**FEMA Levee Certification
Ventura County, California**

**Santa Clara River Levee (SCR-1)
Highway 101 to Saticoy**

**Evaluation Report
February 13, 2009**

Evaluation Report

Santa Clara River Levee, From Hwy 101 to Saticoy, (Photo No. M57) –
Power poles within 15' of levee toe, looking upstream (landward side)

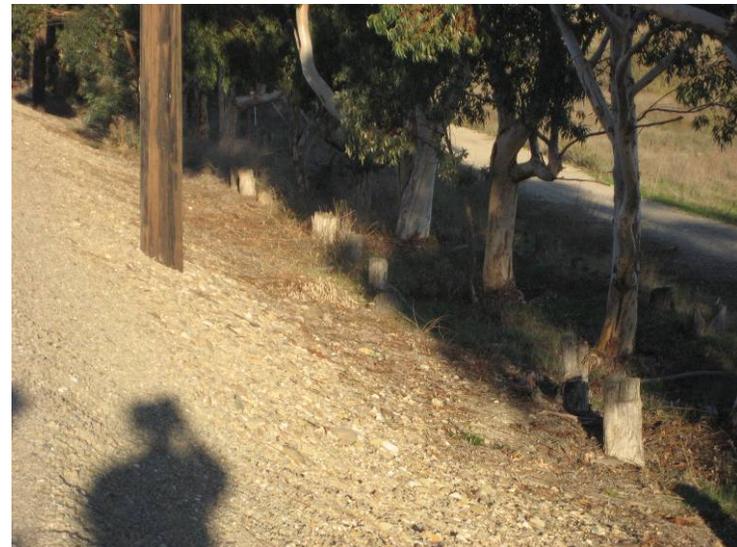
M57, M58	Power poles within 15' of levee toe (landward side)	May require relocation	C5 - Planning to coordinate removal of poles with SCE	E1	Unless major reconstruction, no permits	X	Are all static poles a problem?	Utility poles within the embankment prism (only 1 on SCR-1) must be relocated. These poles do not require relocation.
M59	Tree within 15' of levee toe (landward side)	Remove trees and root ball, fill voids with impervious material and firmly compact.	C1/C4	E1	Landward veg removal not regulated	X	Where does the toe start?	The fifteen (15) foot vegetation line is measured from the visual toe of slope to the center line of the trunk (tree), the closest trunk to the toe (multiple trunk trees/plants) or the stock/stem protruding through the soil (large plant connected to a root system)
M60	Trees, stumps, power poles within 15' of levee toe approximately 1,000' along levee toe (landward side)	Remove trees and root ball, fill voids with impervious material and firmly compact	C1 - for tree removal, C5 - Planning to coordinate removal of poles with SCE	E1	Landward veg removal not regulated, power poles may be issue	X	Are all static poles a problem? Where does the toe start?	Utility poles within the embankment prism (only 1 on SCR-1) must be relocated. This pole does not require relocation.

Santa Clara River Levee, From Hwy 101 to Saticoy, (Photo No. M63) –
Power poles guy wires anchored in levee bank, looking d/s (landward side)

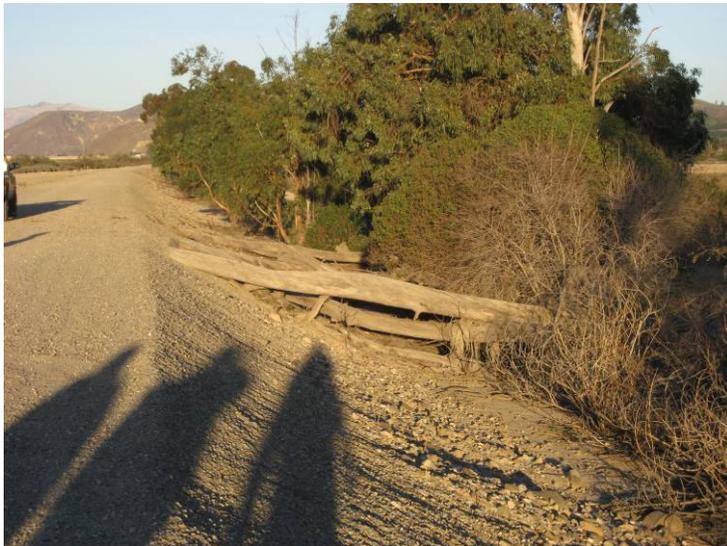
M61, M62, M63, M64	Power pole and fallen trees on levee embankment, guy wires anchored into embankment (landward side)	Remove vegetation and root ball, fill voids with impervious material and firmly compact.	C1 - for tree removal, C5 - Planning to coordinate removal of poles with SCE	E1	Landward veg removal not regulated, power poles may be issue	X		Utility poles within the embankment prism (only 1 on SCR-1) must be relocated. This pole requires relocation.

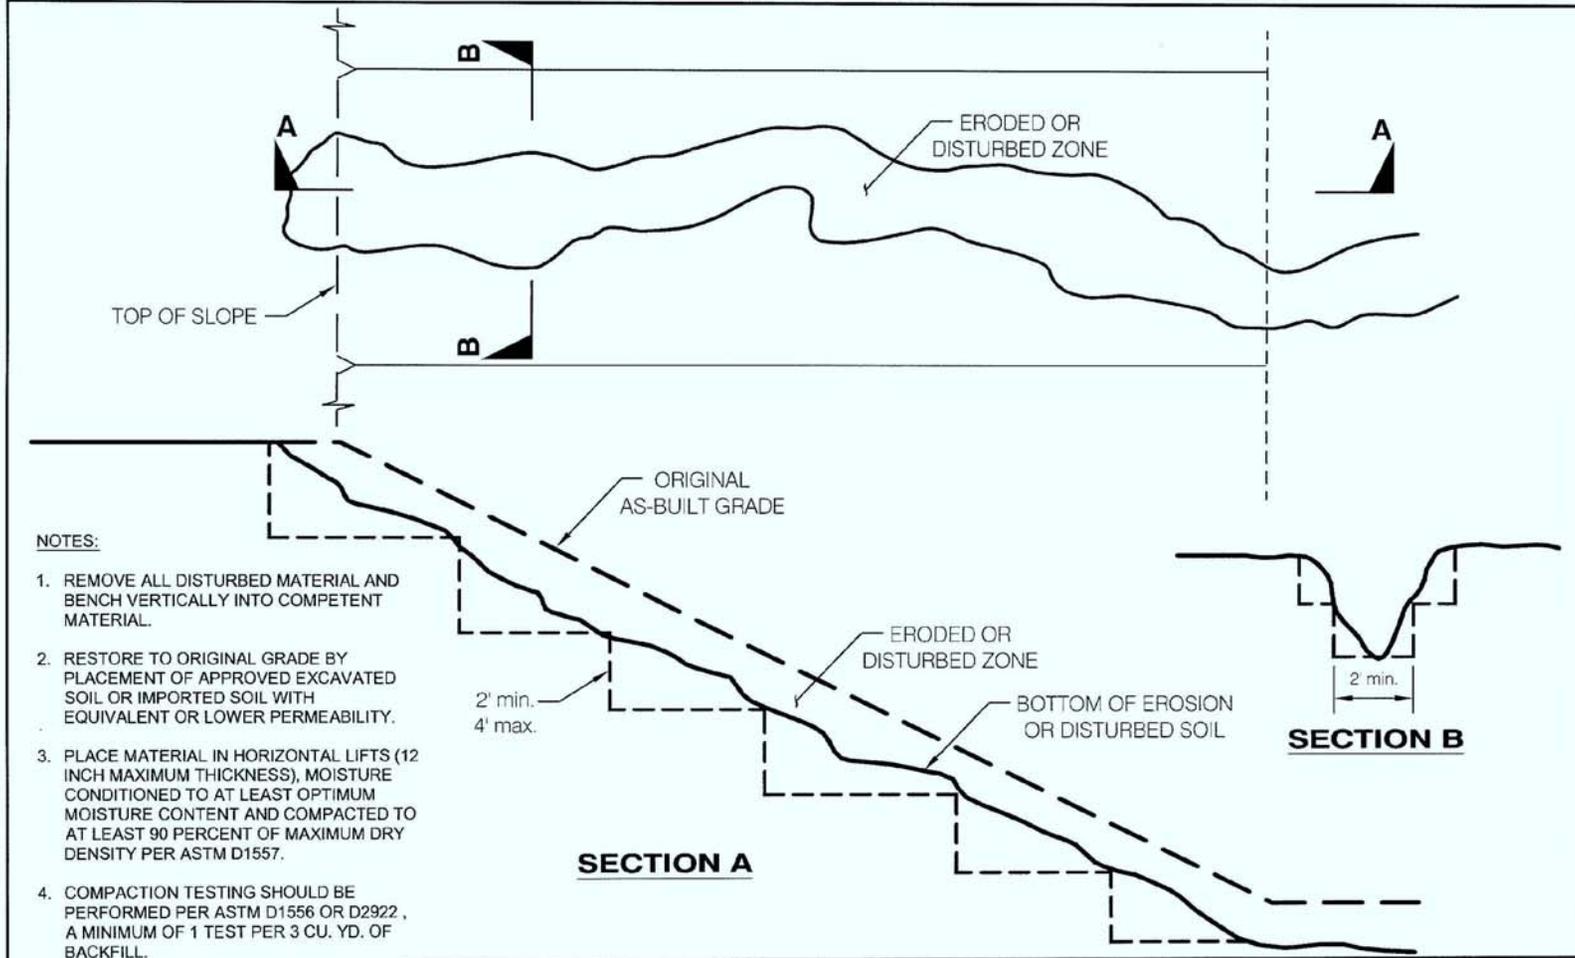
<p>4. Can Tetra Tech provide specs for compaction and grading requirements? Discuss major and minor repair examples.</p>	<p>Compaction requirements are detailed on the attached Figures 1 and 2. Major repair examples include any erosion feature that is deeper than 1 foot or that is greater than 2 feet wide. Major and minor animal burrows are discussed in item 1.</p>
<p>5. Can in-kind materials be used for backfill?</p>	<p>In-kind backfill would be materials free of organic or deleterious debris that has similar or lower permeability than the levee material. These materials could consist of excavated soil, imported soil, concrete, or slurry, and shall be evaluated by the testing and materials lab.</p>
<p>6. Discuss documentation/inspection requirements for verification of grading.</p>	<p>The requirements for verification of grading are discussed above.</p>

1. REMOVE ALL DISTURBED MATERIAL AND BENCH VERTICALLY INTO COMPETENT MATERIAL.
2. RESTORE TO ORIGINAL GRADE BY PLACEMENT OF APPROVED EXCAVATED SOIL OR IMPORTED SOIL WITH EQUIVALENT OR LOWER PERMEABILITY.
3. PLACE MATERIAL IN HORIZONTAL LIFTS (12 INCH MAXIMUM THICKNESS), MOISTURE CONDITIONED TO AT LEAST OPTIMUM MOISTURE CONTENT AND COMPACTED TO AT LEAST 90 PERCENT OF MAXIMUM DRY DENSITY PER ASTM D1557.
4. COMPACTION TESTING SHOULD BE PERFORMED PER ASTM D1556 OR D2922 , A MINIMUM OF 1 TEST PER 3 CU. YD. OF BACKFILL.

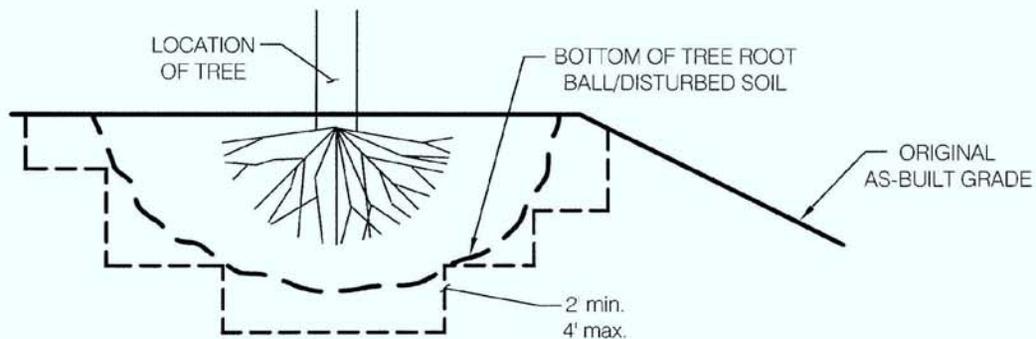
<p>2. Please describe methods for vegetation and rootball removal.</p>	<p>4" DIAMETER TRUNK OR GREATER: Cut the woody vegetation approximately two (2) feet above ground level leaving a prominent stump for use in the rootball extraction process. Remove the stump and rootball by pulling or extracting with a backhoe or similar equipment. Clean the rootball cavity of all loose soil and remaining root system (roots greater than 1/2" diameter). Prepare the cavity by excavating per FIGURE 2. Backfill with excavated soil or imported soil with equivalent or lower permeability. Place material in horizontal lifts no greater than twelve (12) inches. Moisture conditioned to at least optimum moisture content and compacted to at least ninety (90) percent of the maximum dry density of the fill soil per ASTM D1557. Compaction typically requires the use of manually operated compaction equipment or compaction attachment to a backhoe. Compaction testing should be performed per ASTM D1556 or D2922. A minimum of one (1) test per three (3) cubic yards of backfill.</p> <p>2"-4" DIAMETER TRUNK: Cut the woody vegetation stump flush with the ground. Treat the stump with a protective coating similar to polyurethane to prolong the decay process.</p>
